STRAND ROAD TRIAL RAPID DEPLOYMENT CYCLE ROUTE – AN ALTERNATIVE PROPOSAL

BY STC COMMUNITY GROUP
(SERPENTINE AVENUE/TRITONVILLE ROAD, CLAREMONT AND
OTHER ADJOINING ROADS)

V3PC. 11 October 2020

Review of Proposed Strand Road Coastal Cycle Route

Fig 2 – proposed section where existing width allows inclusion of parking zone – minimum width

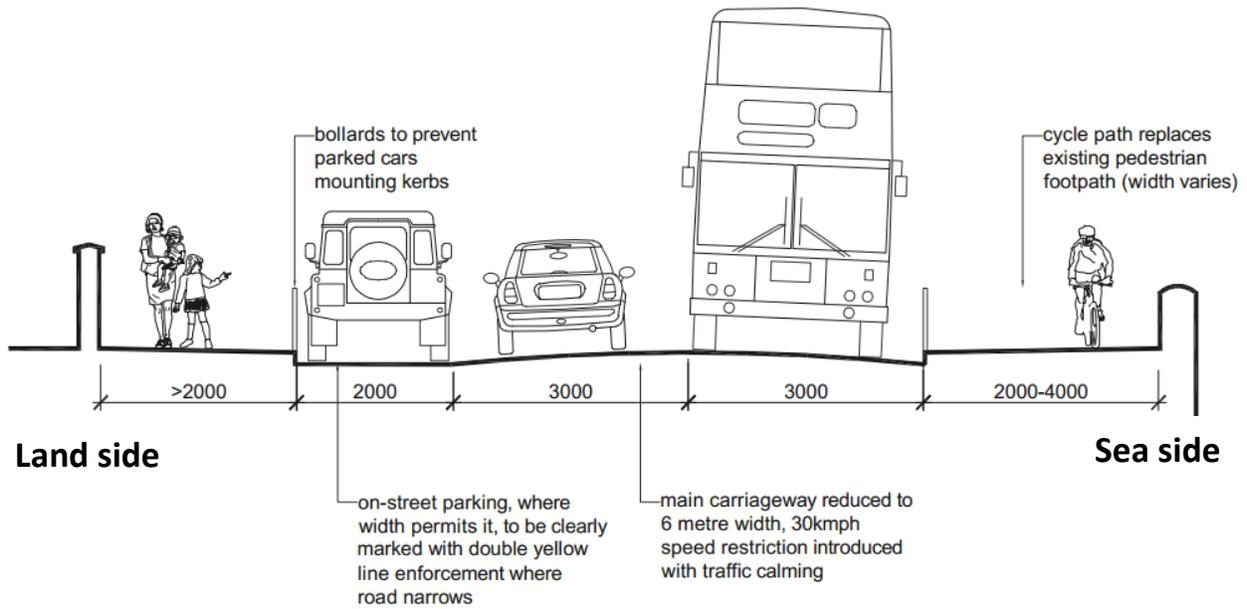
The land side footpath is currently only 1.8m wide so we propose that vertical bollards are installed similar to many places around Dublin, to give an additional clear width of 2m. In areas where the road is wider, parking could be considered. This can be altered easily as the bollards are removable.

As outlined in the 2015 report and verified again on site, the seaward footpath ranges from a minimum of 2.5m to over 4m in width, and the land side footpath is 1.8m.

Fig 3 – proposed section excluding parking – minimum width

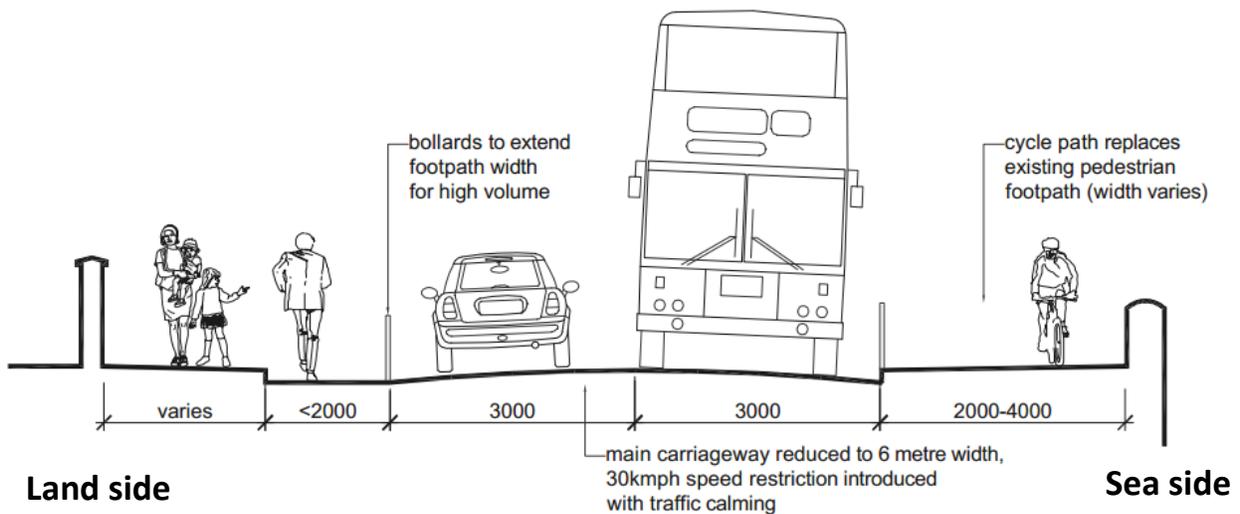
We propose, for the most part, the seaside footpath be used as it is for a 2-way cycleway, with pedestrians on the landside path. The seaside path is 4m for the most part, increasing and decreasing for short stretches.

Fig 5 - graphic showing proposed chicane traffic calming located at pinch points + crossing points

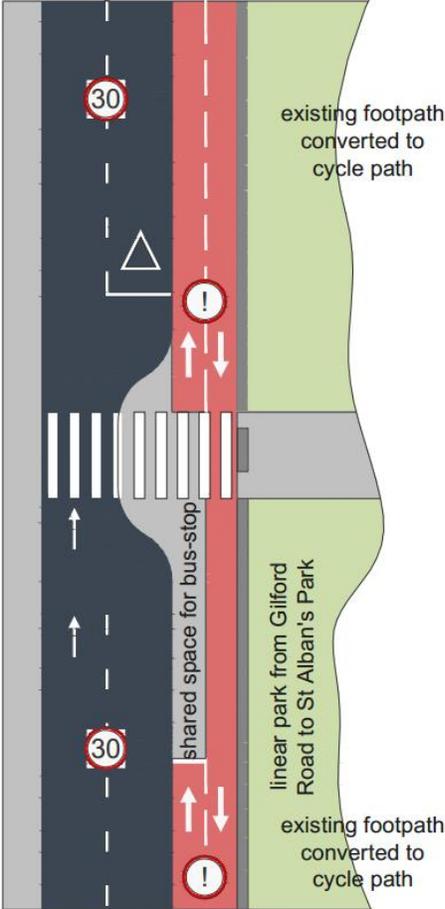
Fig 6 – traffic calming chicane to pinch point where the linear park begins. Where there are bus-stops there will a necessity to share the cycle lane space with people alighting, who will then be directed to crossing point

Fig 8 - section from St Alban's Park to Merrion gates

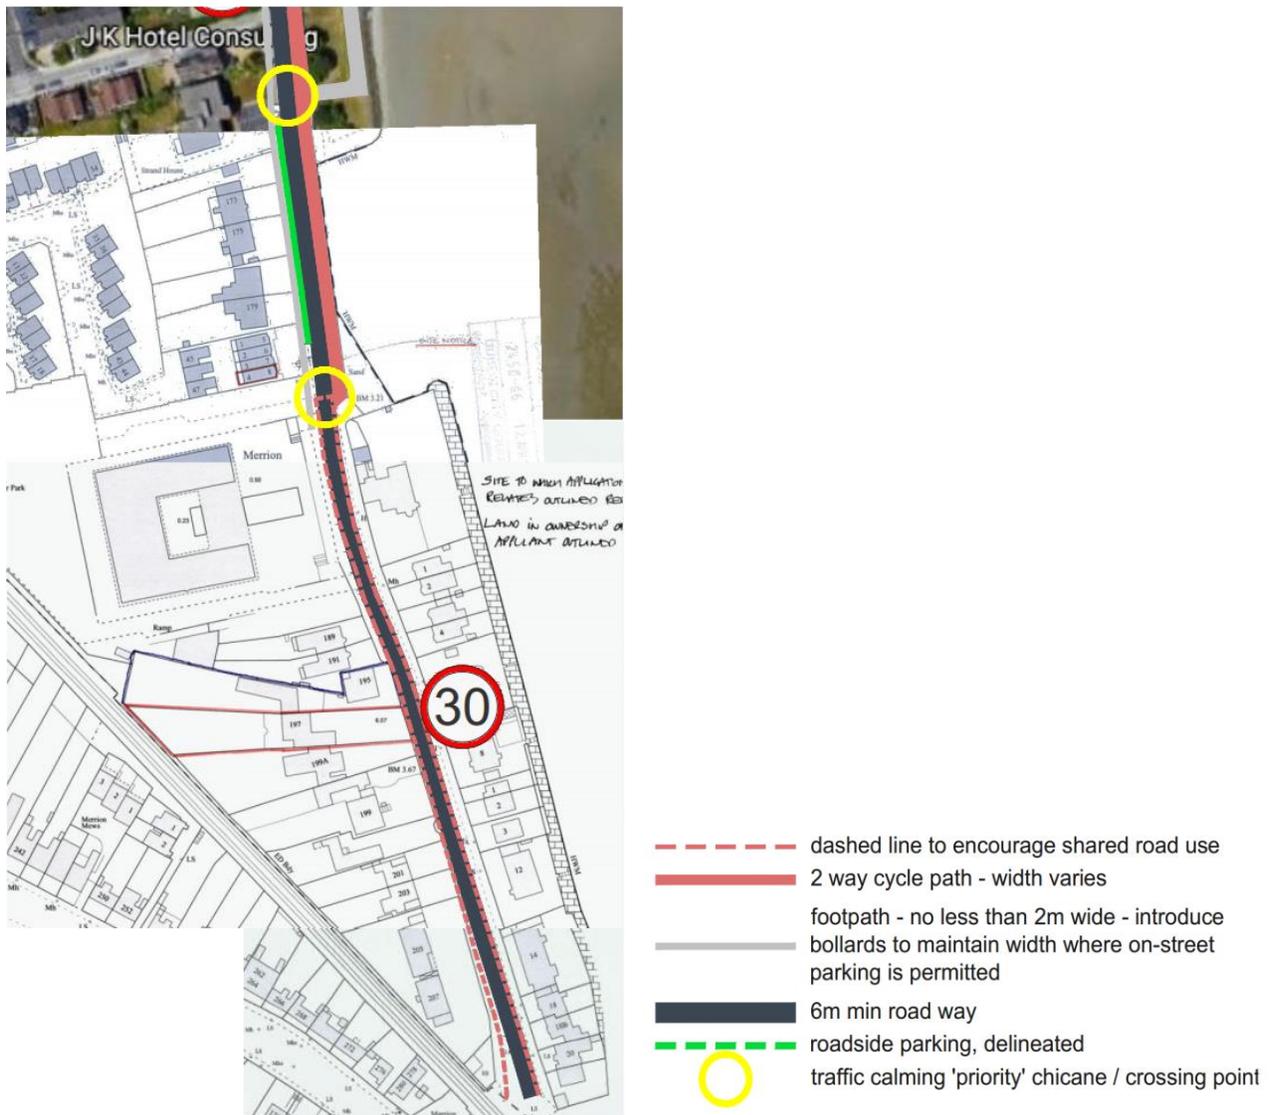
For the “infill section” between the promenade and houses, the carriageway is 7.5m wide and seaside footpath is 4.5m. By reducing the carriageway to 6m, the footpath could be widened to facilitate a 6m wide shared cycleway and footpath.

Or alternatively a similar approach to the earlier design could be used, with 1.5m of carriageway allocated to the pedestrian landside path.

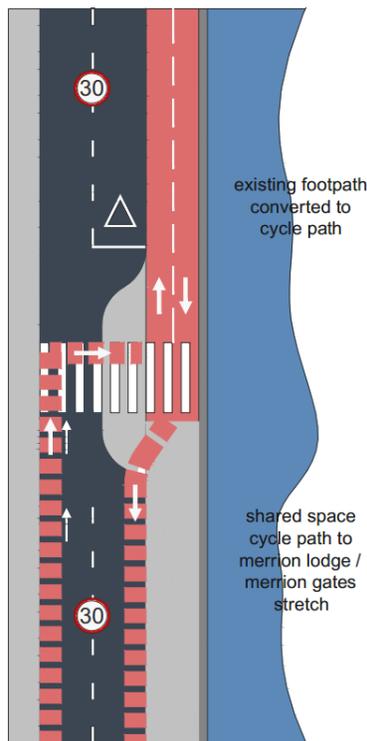
In the mean-time we feel a shared space is a reasonable compromise given the cycleway is not connecting to anything after the Merrion Gates. To make it feel like a shared space, have a raised table, put in rumble strips, different coloured path and install a priority cycle gate. Additional toucan crossings before and after the shared space will also help.

Fig 9 – traffic calming chicane to pinch point at the end of the sea wall – the road which leads to this point will have dashed cycle lane lines to either side and reduced speed limit to ensure a safer shared space and will remind queued traffic to leave space for cyclists. The traffic calming will have the added benefit of making it safer for cyclists to cross to the 2 way cycle lane
